Legislative & Planning Services
Planning Services
1151 Bronte Road
Oakville ON L6M 3L1

Re: Halton Municipalities' Comments on CN's Responses to Review Panel's Information Requests (IRs) - Ultimate/Maximum Intermodal Terminal Capacity of the Milton Logistics Hub

Re: Proposed CN Milton Intermodal Terminal Logistics Hub Project – Federal Environmental Assessment (EA) Panel Review and Section 98 (2) CTA Application Sustainable Capacity Analysis and Estimate

Approximate Intermodal Terminal Operational Area Acreage Calculations

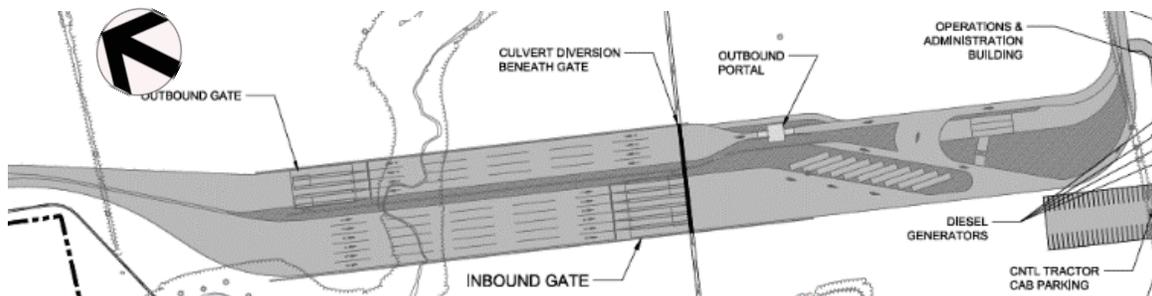
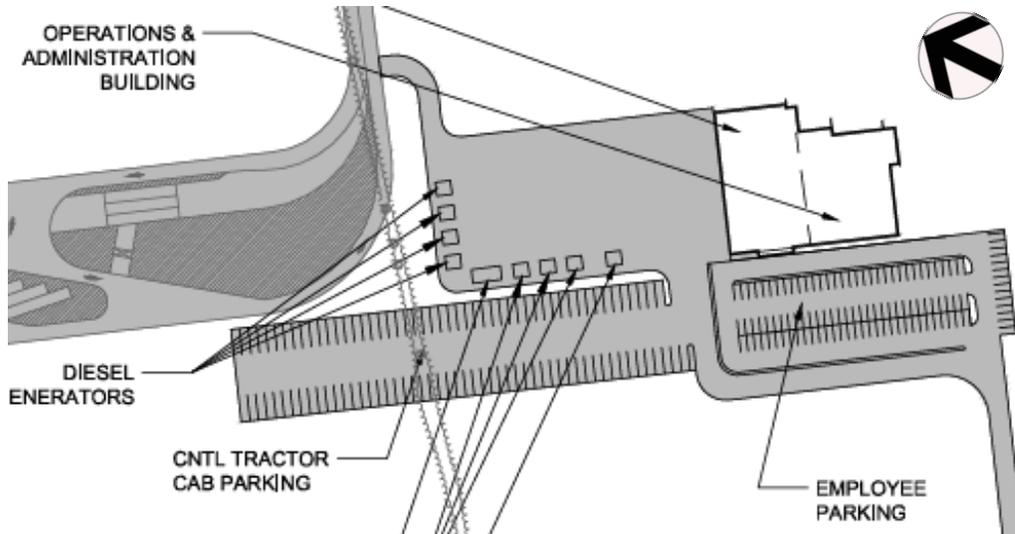
As depicted in CN's Attachment IR2.26-1, Drawing No. 01-SK-01, the following intermodal terminal general areas are illustrated and their respective approximate terminal areas were calculated. The areas are generally based on my professional expertise and experience (such as estimates for usual and customary container storage stacking heights) as well as notes and indications on the CN engineering site plan drawings.

- 136 m. wide x 2,360 m. long – Effective area = 136 m. x 2140 m. = 291,040 sq. m.
 - 446 ft. wide x 7,743 ft. long – Effective area = 446 ft. x 7,021 ft. = 3,131,366 sq. ft.
- 71.89 acres**

- 64 m. wide x 530 m. long – Effective Area = 72,080 sq. m.
 - 210 ft. wide x 1,739 ft. long – Effective Area = 365,190 sq. ft.
- 8.38 acres**

- 160 m x 52 m – Effective Area = 8,320 sq. m.
 - 525 ft. x 171 ft. – Effective Area = 89,775 sq. ft.
- 2.06 acres**
